## Overgate Mealsgate – Statement of Changes due to Structural/Building Regulation issues- February 2025

Whilst permission was obtained for various works during the construction a greater understanding was gained revealing structural issues or building issues conflicting with current building regulations which required some minor amendments: -

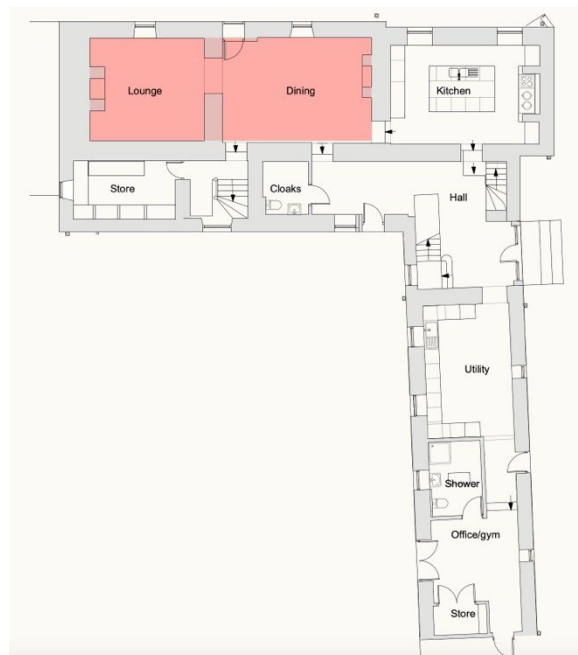
The ground floors were in a poor condition and needed replacement (see engineers report). In addition our client wanted to install a ground source heat pump with underfloor heating rather than radiators which would better suit the historic nature of the building together with floor insulation and a damp proofing. Approval was given to replace the floors (LBC/2023/0019).

With this trial holes were excavated against the main house walls which identified the walls to be founded at a shallow level. Significant underpinning would have been required to facilitate the new ground floor construction. The walls are formed in random stone rubble fill and appeared loose in many locations; local collapse was a real potential should the walls be undermined. The engineers opinion was to lift the floor level to allow the new floor construction to be achieved without undermining the existing structure. In addition in some areas external ground levels were higher than internal floor levels

which would not comply with todays building regulations and lead to damp issues. ( BRegs Document C Para 5.5 – diagram 9 below).

Permission was given to insulate and replace floors and with the above engineers comments, to avoid walls collapsing and to comply with todays building regulations it was necessary to raise the floor slightly in the living room and dining area which also helped with damp issues.

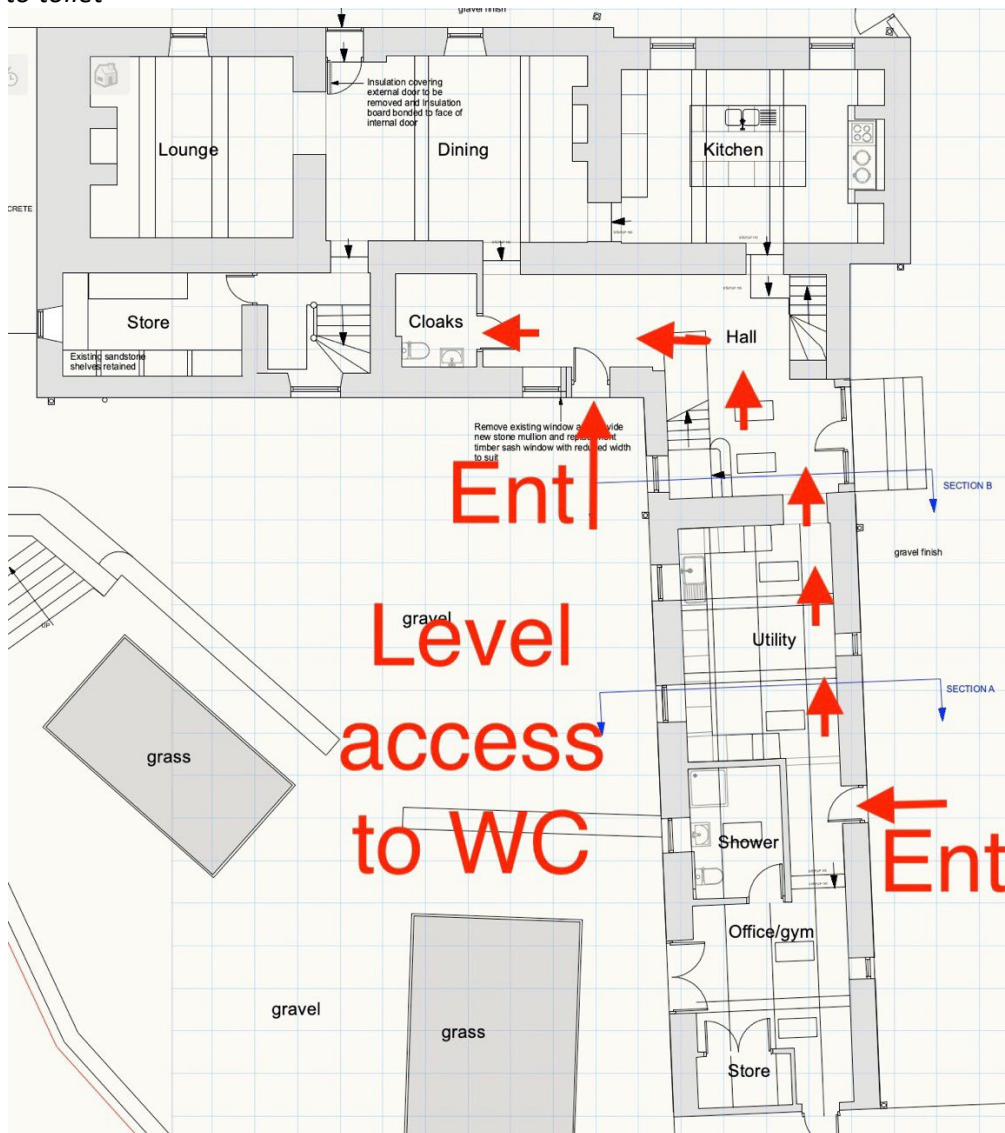
The external level access entrance to the barn and utility area leads into the link building and into the upper ground level of the farmhouse where the accessible toilet is located. Due to existing ground levels this results in external steps to the main entrance and a low floor to ceiling level under the first floor balcony (2.13m).

Level access to rear door and office door leading to level access to toilet

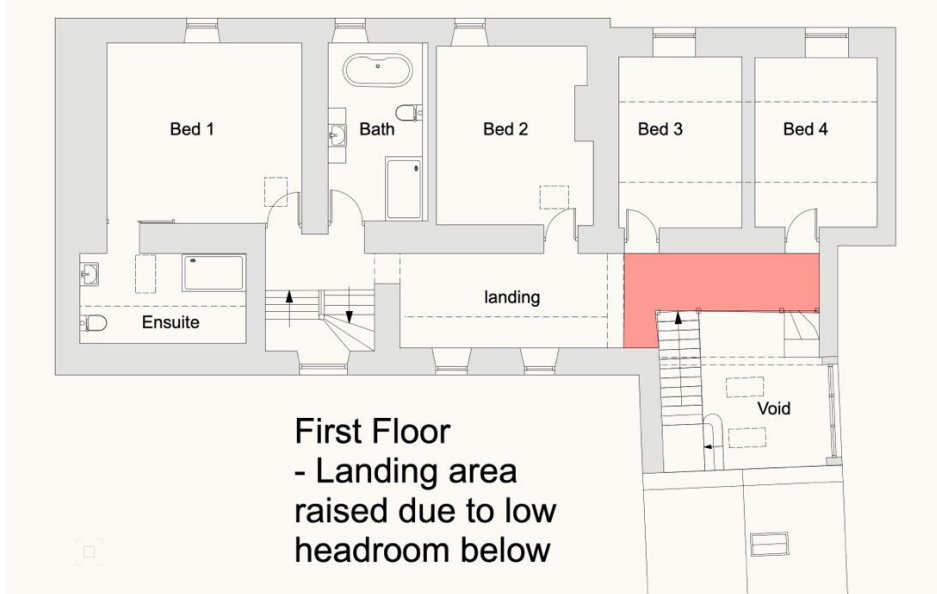
Approval was given to remove bathroom, wc and stores in the sloping area of roof which had limited headroom to allow a more open plan and brighter landing area however the approval did show a step down on the landing. As noted above headroom at ground floor under the landing is low (2.130m) and a step down on the landing would reduce headroom to less than 2m which would be unacceptably low.

1 - Light and airy First floor Landing area

2 - Limited headroom under landing

**Stone staircase plan & Section**

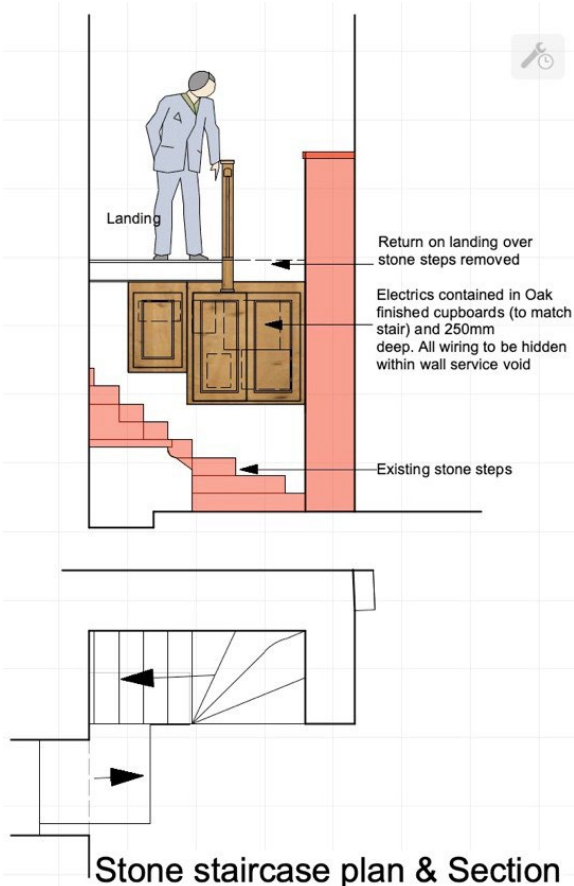
The one area not shown was the external section of wall adjacent the stone staircase. This wall however contained the existing electric meter and fuse board to which all circuit wiring returns which originally together with the stair was hidden in a modern partition enclosure with sliding door. It was agreed the feature stone stair should be open to view due to its historical significant and remain a feature in the building. With no wall lining the area of north facing wall is a cold bridge and there was found to be rising damp issues.

Therefore in accordance with BRegs Document C Para 5.10 – diagram 11 the lining of the wall is necessary to prevent damp issues. This has the huge benefit of creating a service void to hide all wiring to and from the existing circuit board. There are further plans to enclose all electrical equipment in a close fitted wall cupboard above the stone stair which will be subject to a further LBC application.

*Illustration 4 – Lining to wall and proposed*

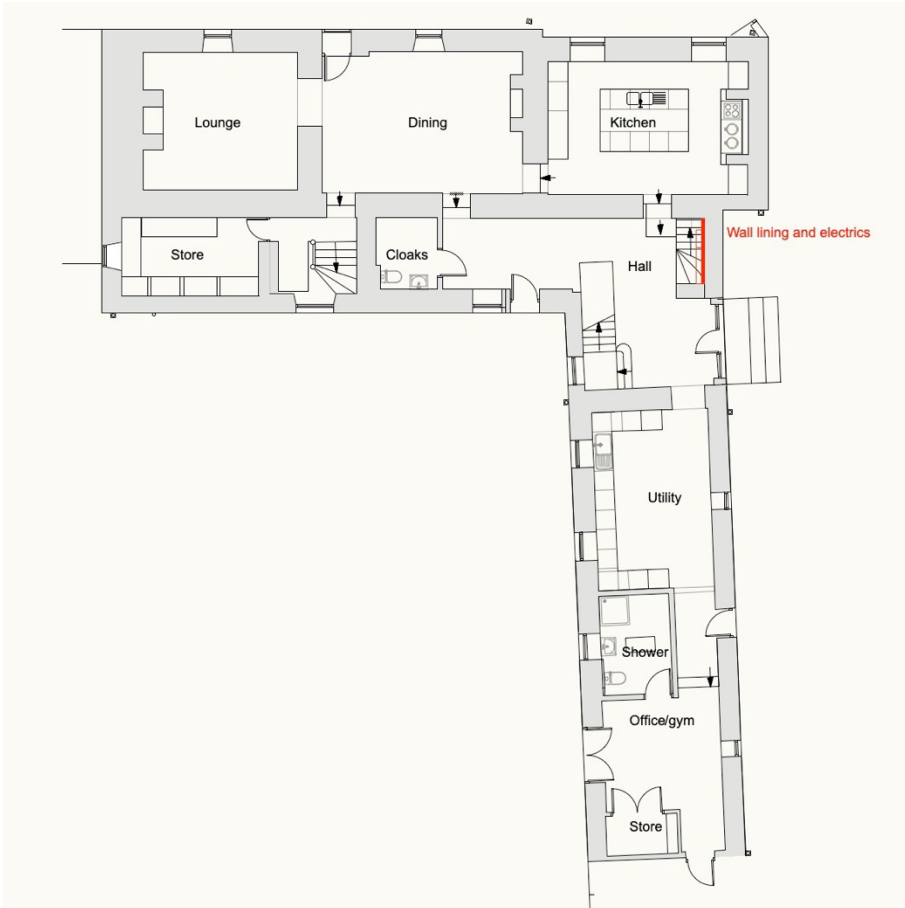
Wall lining and electrical equipment – all other external walls lining approved

*Illustration 5 - Window lintel and truss padstone above windows outlined in red*

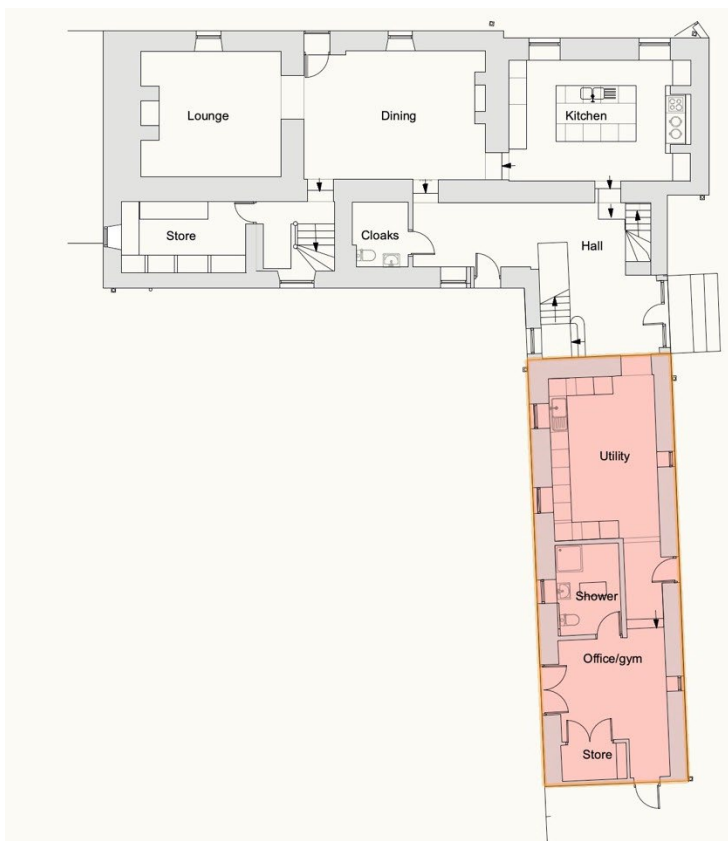
Approval was given to convert the single storey barn to provide a farm office, shower/wc and utility space including the refurbish of the roof slating and replacement of rotten timber roof trusses. The roof was in a poor condition with holes in the roofing due to slate loss or slip. The replacement roof trusses which matched existing sit on pad stones and in some areas are

located above window lintels which dictated the height of the roof.

In addition the original slightly undersized roof rafters needed replacement due to rot with slightly taller rafters specified by the engineer and given approval. The taller rafters also allowed thicker insulation to be incorporated in the roof to reflect current thermal regulations in the building regs. (Building Regs Document L Table 4.2 Limiting U values in existing buildings)

All of the above with an element of levelling of the top of the wall resulted with a slight increase in the eaves height which was made up in stone to match the existing stonework.

Illustration 6 –View of Entrance hall and staircase  
Steelwork spring point set out by door head height (highlighted in the red circle)

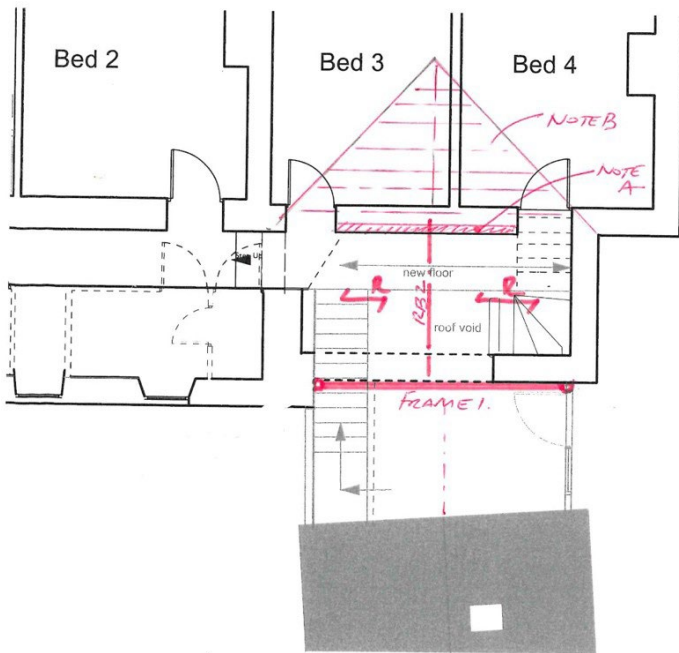
With the development of the engineers steelwork proposals for the link there is a increase in height of a short section of the eaves on the two storey extension however ridge height as been maintained in this area. As can be seen in Illustration 6 the steelwork for the link springs from the head of the door into bed 3 and was kept as low as possible appreciating the sensitive nature of any extension.
